Device TC39x
Marking/Step (E)ES-BD, BD
Package see Data Sheet

10219AERRA

This Errata Sheet describes the deviations from the current user documentation.

Figure 2 Message buffer transfer from Message RAM to OBF

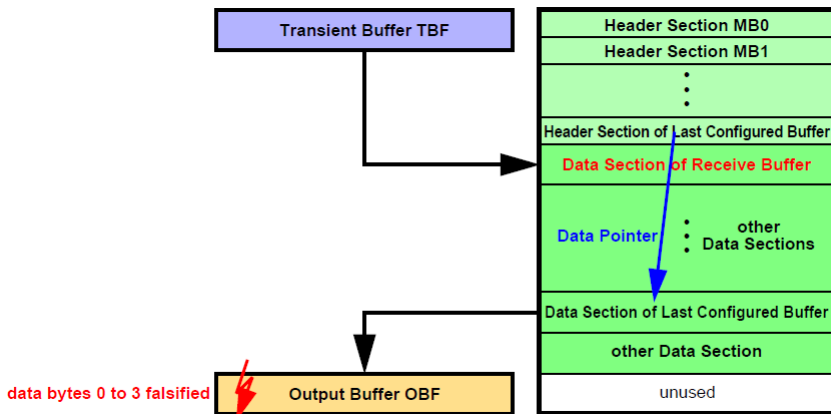
When the message buffer has its payload configured to maximum length (**PLC = 127**), the OBF word on address 00h (payload data bytes 0 to 3) is overwritten with unexpected data at the end of the transfer.

a) When a message is transferred from the Last Configured Buffer in the Message RAM to the OBF and **PLC** = 127 it may happen, that at the end of the transfer the OBF word on address 00h (payload data bytes 0 to 3) is overwritten with unexpected data (see [Figure 2](#)).

Figure 3 Message buffer transfer from IBF to Message RAM

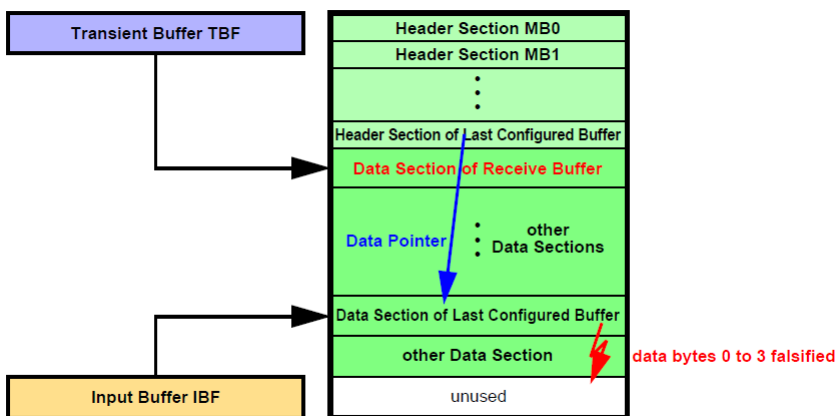
After the Data Section of the selected message buffer in the Message RAM has been written, one additional write access overwrites the following word in the Message RAM which might be the first word of the next Data Section.

b) When a message is transferred from IBF to the Last Configured Buffer in the Message RAM, it may happen, that at the end of the transfer of the Data Section one additional write access overwrites the following word, which may be the first word of another message's Data Section in the Message RAM (see [Figure 3](#)).

Figure 4 Message RAM Configurations

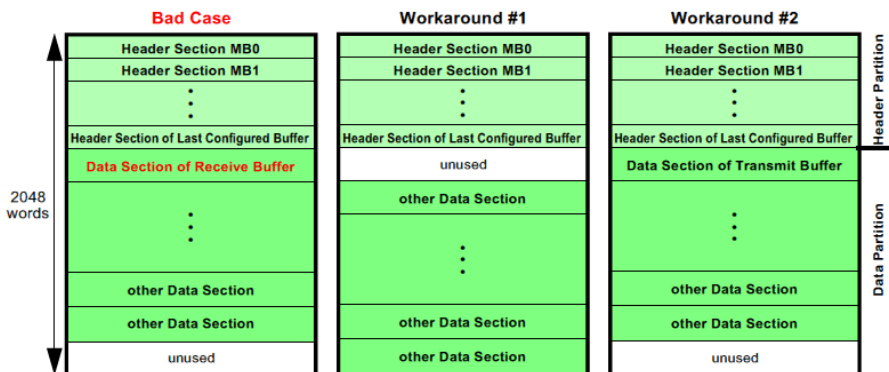
The erratum is limited to the case when (see [Figure 4](#) “Bad Case”):

2) Ensure that the Data Section directly following the Header Partition is assigned to a transmit buffer.

Figure 7 Critical MCS AEI master scenario

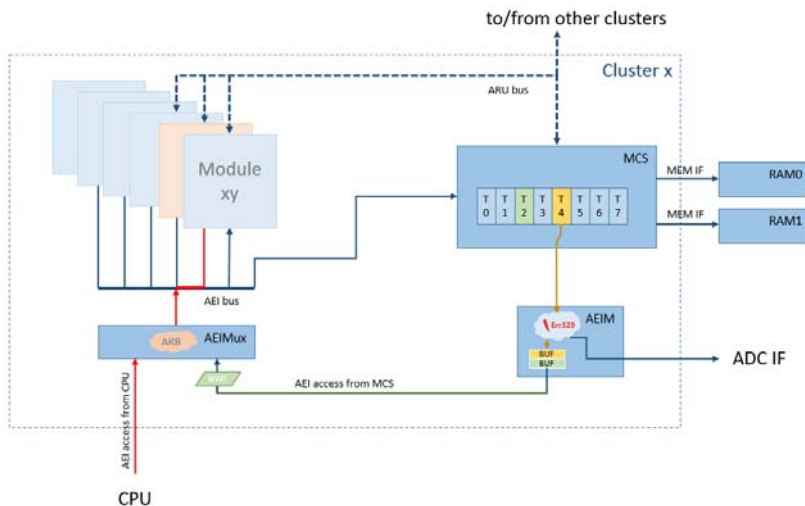
In [Figure 7](#), a potential risk for the occurrence of problem GTM_AI.329 is illustrated. Here the first buffer of the AEIM (green) is still waiting for the access to the AEI bus while a second AEI bus access from MCS arrives at the AEIM (yellow access path). Under certain, but for the user unpredictable timing conditions, this second AEI bus access arriving at the AEIM can trigger the misbehavior described in problem GTM_AI.329.

The workarounds described in the following section will ensure that not more than one AEIM buffer will be filled and therefore the occurrence of problem GTM_AI.329 is avoided. All workarounds have been tested and proven correct.

Figure 10 Interrupt Level vs. Pulse-Notify mode - Corner Case Example

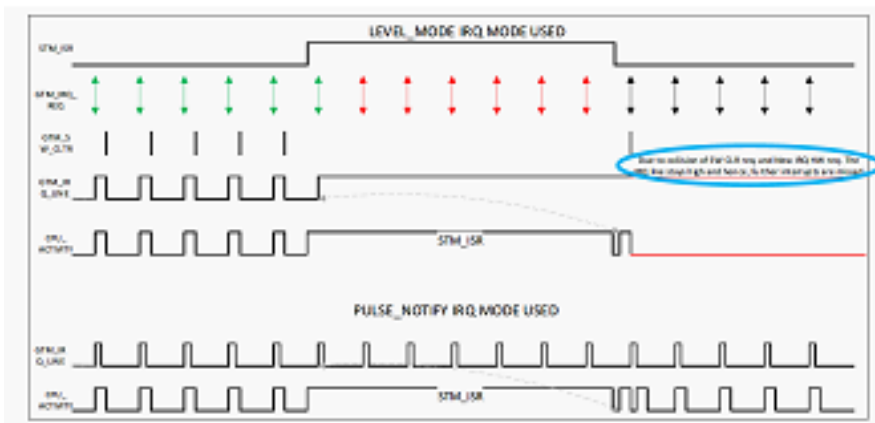
As described in the text below this figure, while using Level mode, if more internal “interrupt” events are generated (i.e. two TOM channels generating a CCU0 interrupt), just one interrupt signal is sent to the IR, and no more interrupts are triggered until the SW clears the GTM_IRQ_XXX line towards the IR.

Hence, in Level Mode, in some scenarios where another interrupt request is generated by GTM while the ISR handle also requests a SW clear, then, as the interrupt event is dominant over the clear event (for simultaneous interrupt and clear events), GTM_IRQ_XXX is not cleared and remains high. As a consequence, the IR observes no transition on GTM_IRQ_XX. Thus, any forthcoming interrupt events in this scenario are lost as there is no chance to release the CPU IRQ when a collision happens as shown in Figure below.

If Pulse-Notify mode is selected, every internal trigger will be forwarded to the IR, irrespective of the time of occurrence and the clear event, as the pulse-notify leads to set and reset of GTM_IRQ_XXX as compared to only setting of the GTM_IRQ_XXX line in Level mode.

Figure 12 ADC Trigger Concept

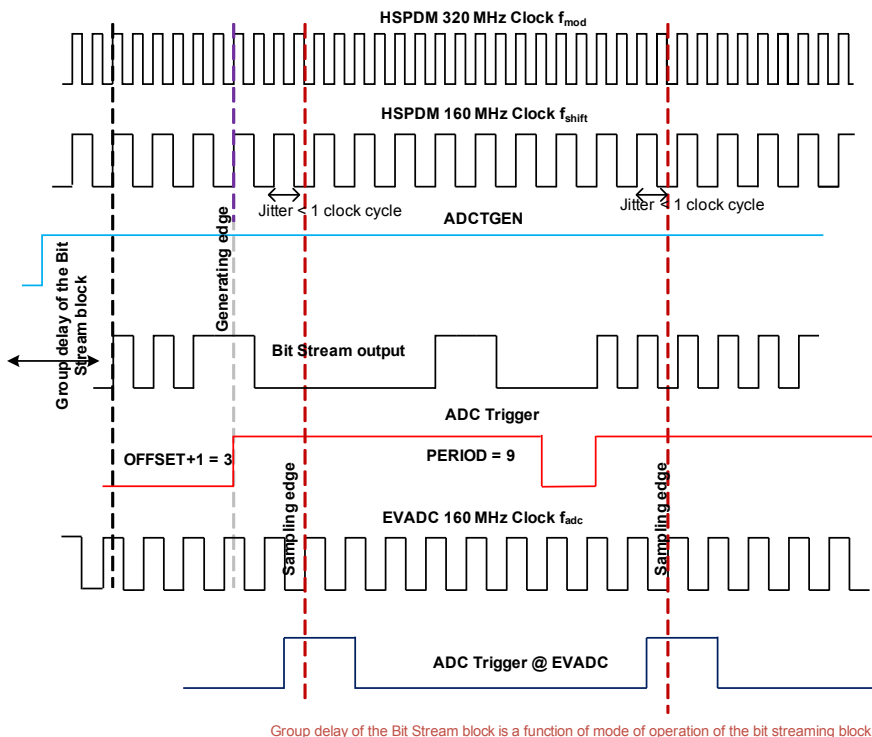
HSPDM_TC.H004 ADC Trigger Concept - Figure update

Figure “ADC Trigger Concept” in the current version of the HSPDM chapter of the TC3xx User’s Manual shall be replaced with the following updated figure:

Figure 13 SDIO Card Interrupt Sequence

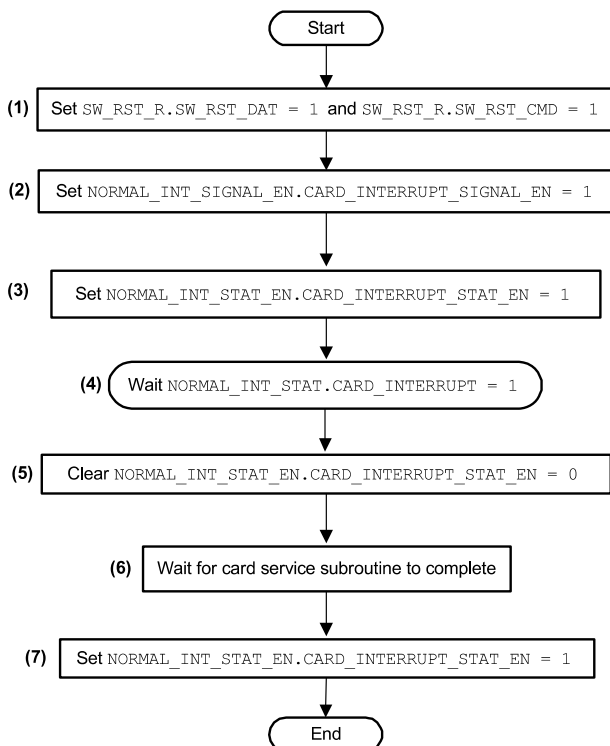
SDMMC_TC.H002 SDIO Card Interrupt Sequence - Figure update

Figure “SDIO Card Interrupt Sequence” in the SDMMC chapter of the current version of the TC3xx User’s Manual is wrong. The correct sequence is shown in the following [Figure 13](#).
